SUBJECT: Responds to NRC 790925 ltr re loss of offsite power events.
 One partial loss of offsite power & two complete losses of
 offsite power events since initial operation. Three partial
 or complete loss of power events before plant operation.

Subject: Loss of Offsite Power Events at the
R.E. Ginna Nuclear Power Plant
Docket No. 50-244

ATTACHMENT I		
GINNA STATION - ON-SITE/OFF-SITE		
ELECTRICAL SINGLE LINE DIAGRAM		
JOB NO.	DRAWING NO.	REV.
		△

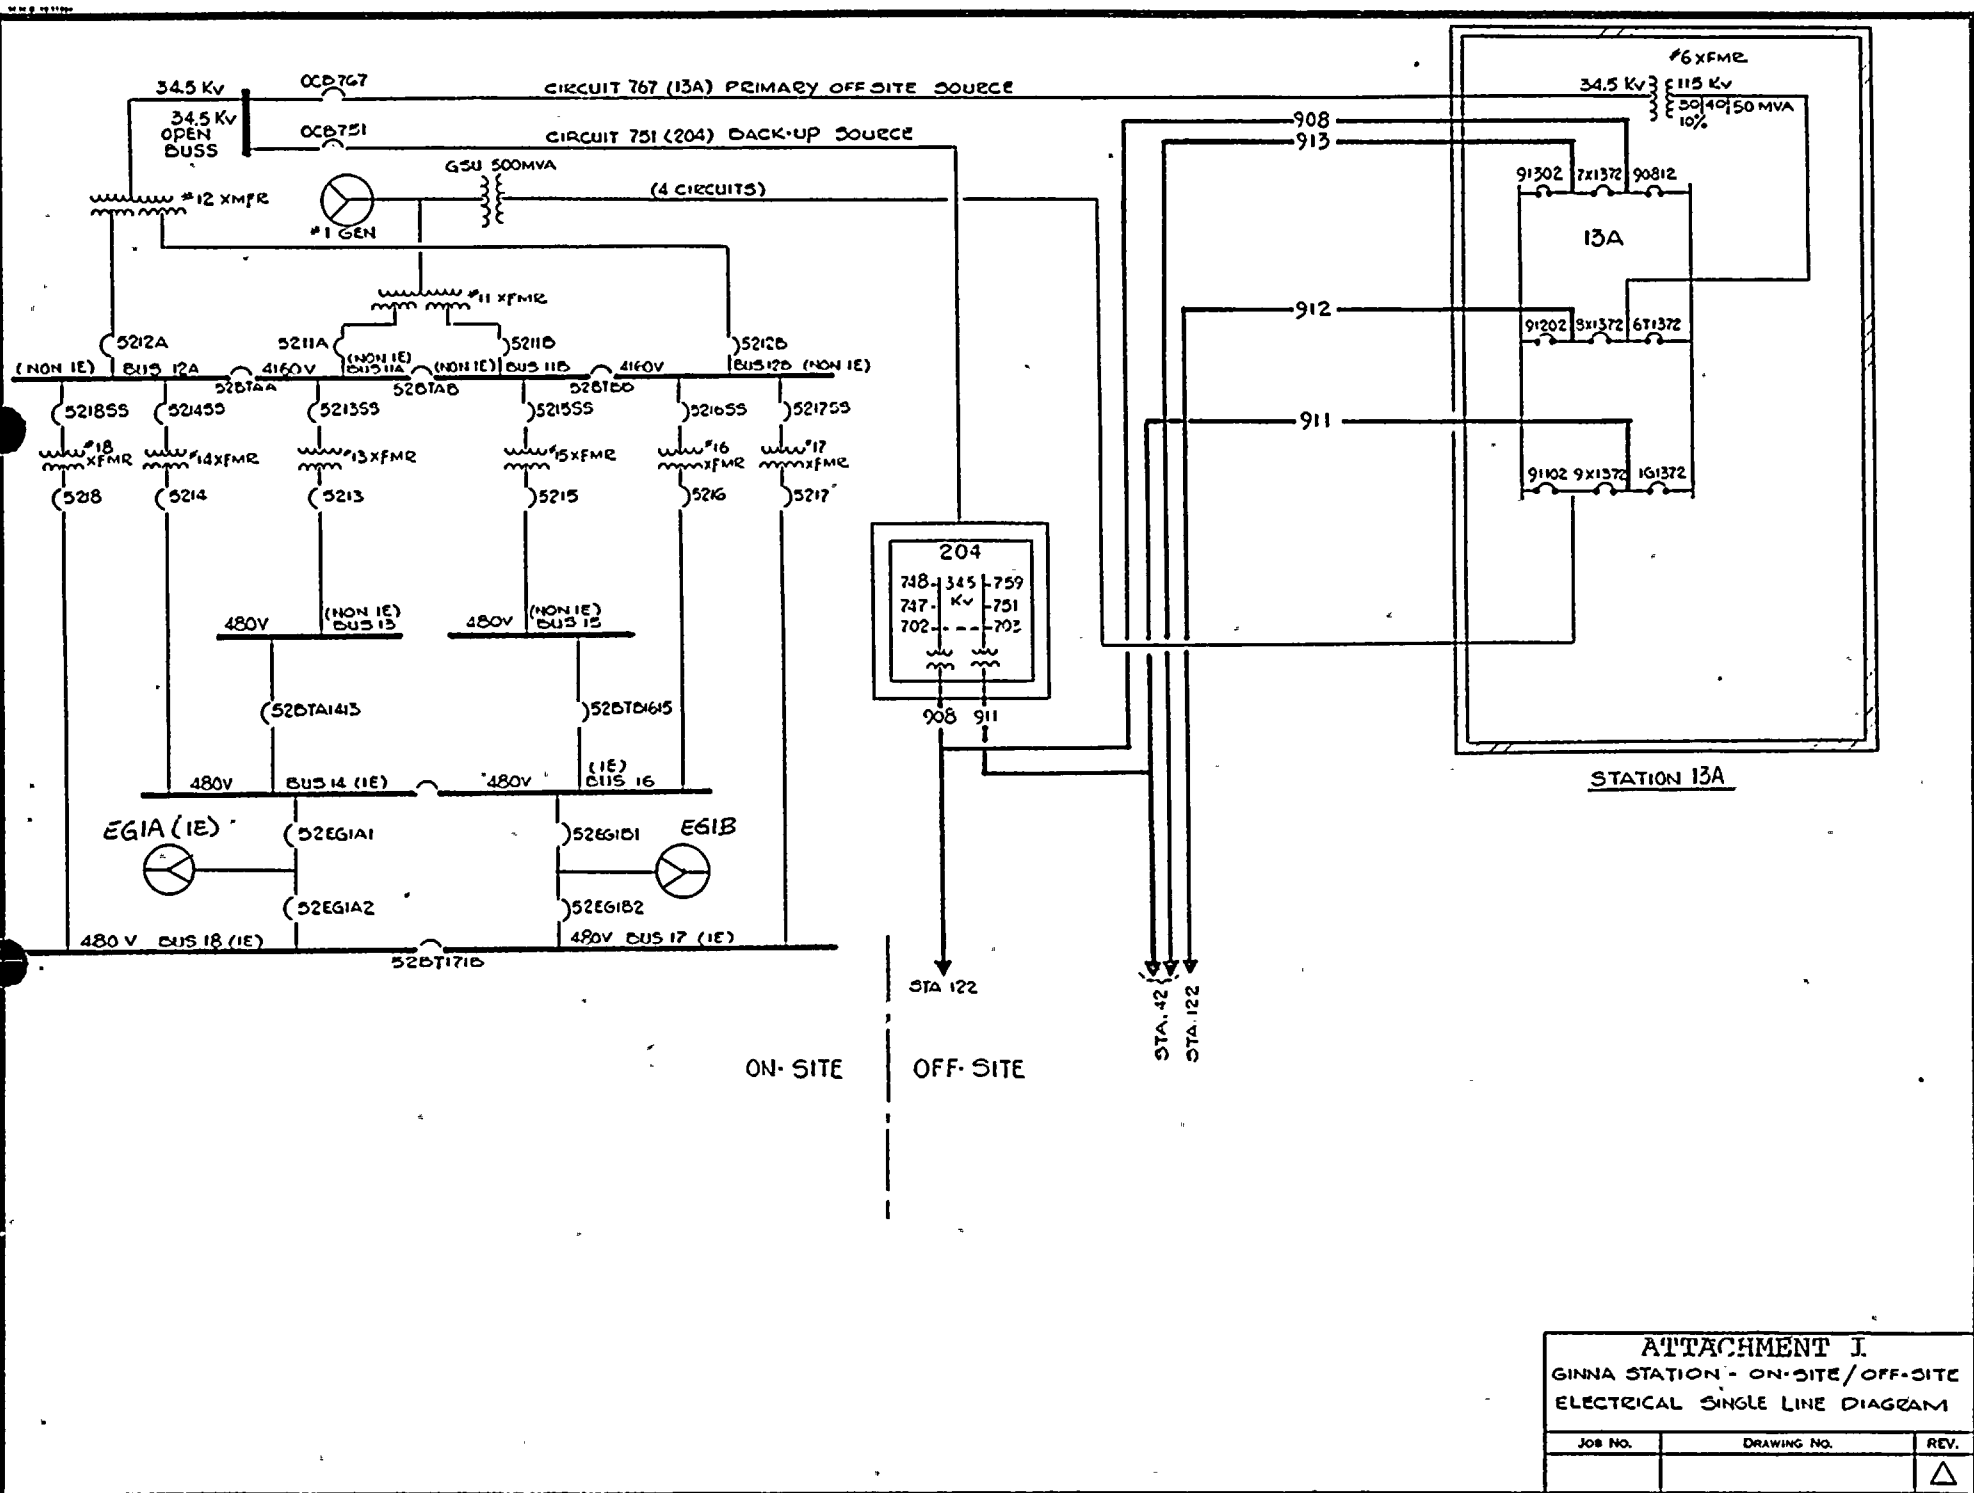
Question: 1. How many circuits to the offsite network are normally available and how many were lost during the event?

Question: 3. Why did the other lines not fail when some did fail?

Event 1: Attachment I is a single line diagram of the offsite power system as well as the in-plant bus arrangements for Ginna Station. From this diagram it can be seen that the primary offsite source is circuit 767 which is supplied by the 115 kV grid through number 6 transformer. On January 2, 1971, a bushing failure on number 6 transformer occurred taking it and consequently 767 circuit out of service. When this occurred the two onsite diesel generators automatically started. The safeguard loads, however, were manually placed onto the backup offsite source, 751 circuit.

Response: The primary offsite source, 767 circuit, was lost during this event but the backup source, circuit 751, was manually placed into service.

Response: Circuit 751 emanating from Station 204 remained energized during this event because the two 115 kV lines, circuits 908 and 911, the two sources for 751 circuit, remained in service.
